SSC End Part Modifications

The first coils with "developable surface, grouped" end parts were wound and cured in June 1990. These are the first parts made by programs written by Joe Cook. The coils are SSC 40mm C358 short coils. The lead end parts were manufactured by Texas Instruments. Return end parts are made by T & R Industries in Red Rock, Texas. All parts were inspected and are made according to the points specified in printouts produced by Fermilab.

Figure 1.

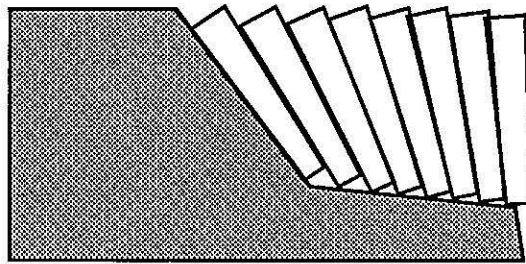
- 1.) During winding, the cables are not yet compressed into their final cured size. They are thicker than they will be after curing. The space allowed for the cables by the end parts is only enough for a cured, compressed cable. As a result the last turn in a current block may extend past the end of a shelf during winding as shown in Figure 1.

Figure 2.

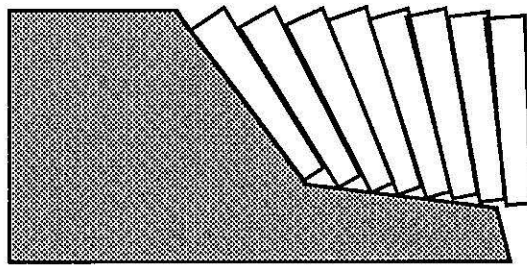
This occurs for both the individually determined and grouped ends, but the effect is worse for grouped because the space allowed for the bottom edge of the cable is smaller. If the difference between the compressed and uncompressed current block is less than one cable width, this is not a problem. The cables are pushed into their final position when they are compressed. If, however, the current block is more than one cable width larger in the uncompressed state, the final turn is, before curing, completely beyond the end of the shelf as shown in Figure 2. The turn must then be pushed into its final position in the curing mold. The final turn can become lodged between the shelf and the adjacent end part, causing the end to fail to close or insulation damage to the cable. This possibility becomes progressively more likely as the current blocks become larger.

The situation in Figure 2 occurred for the first current block in these coils. This current block has 11 cables. This will be solved by artificially extending the shelf and undercutting the adjacent part as shown in Figure 3.

Figure 4.

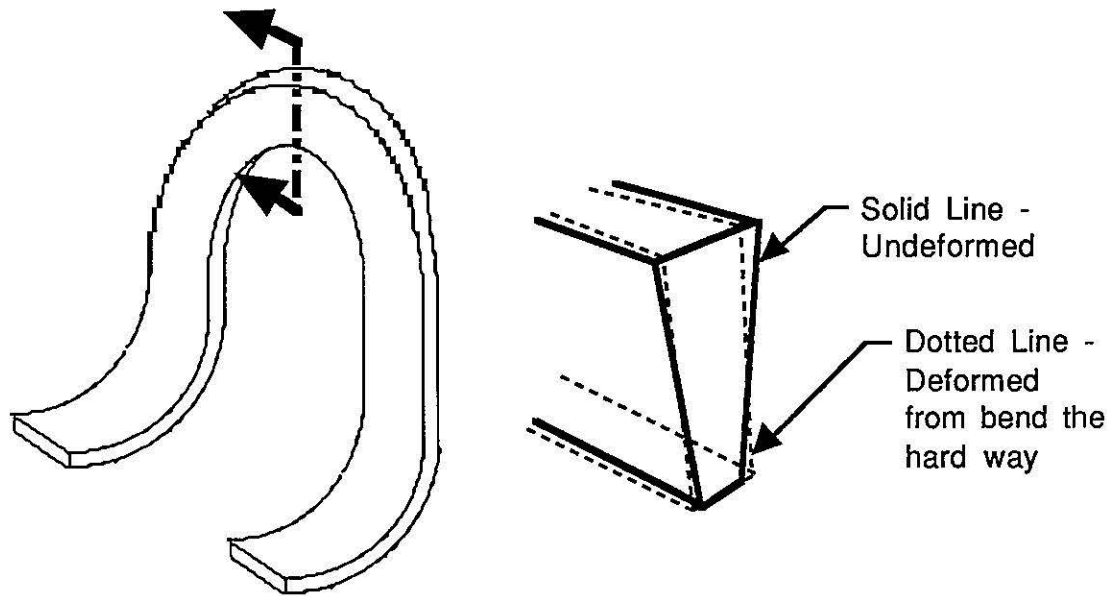
- 2.) Cables, as they are wound around the ends, are unavoidably subjected to stresses due to the bend the hard way, bend the easy way and twist. These stresses result in local changes in the cross sectional shape of the cable. Two types of changes have been observed.
 - a.) The cable becomes "unkeystoned" due to the bend the hard way. As a cable is bent the hard way, the top (thick) edge becomes thinner while the bottom (thin) edge becomes thicker as shown in Figure 4. This is the most pronounced effect.

Figure 5.

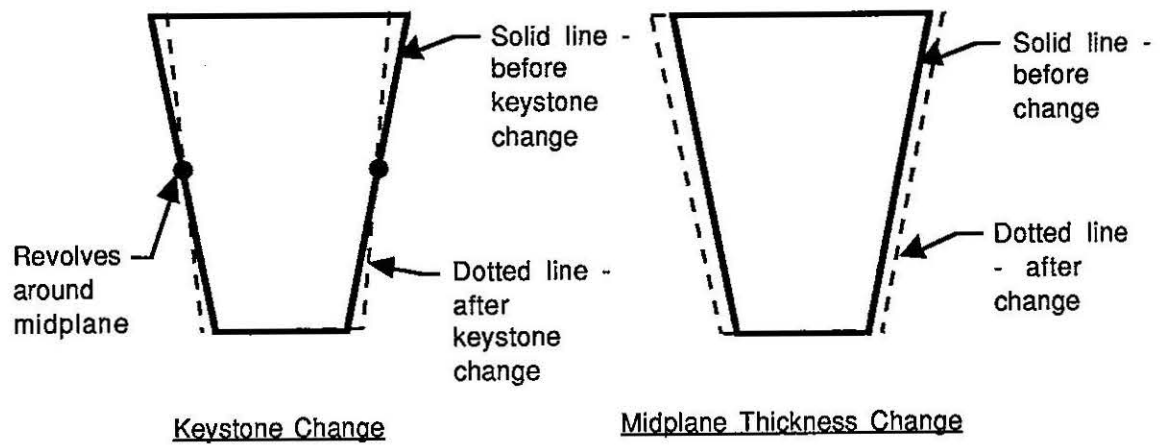
The end program has been modified to accept local changes in cable shape. Both keystone and midplane thickness can be altered independently as shown in Figure 5. The changes are input based on empirical data.

- At the beginning of turn (where the straight section ends) the cable is at the nominal compressed shape. Between the beginning of turn and a point halfway between the beginning of the turn and center of turn the cable is smoothly increased by 3% in midplane thickness while decreasing in keystone by 40%. From here to the center of turn, the midthickness decreases back to the nominal and the keystone increases by 10% (thereby becoming decreased from the nominal by only 30%). These conditions are mirrored on the other half of the turn.
- Shelves will be extended by .125 inches and adjacent parts will be undercut.
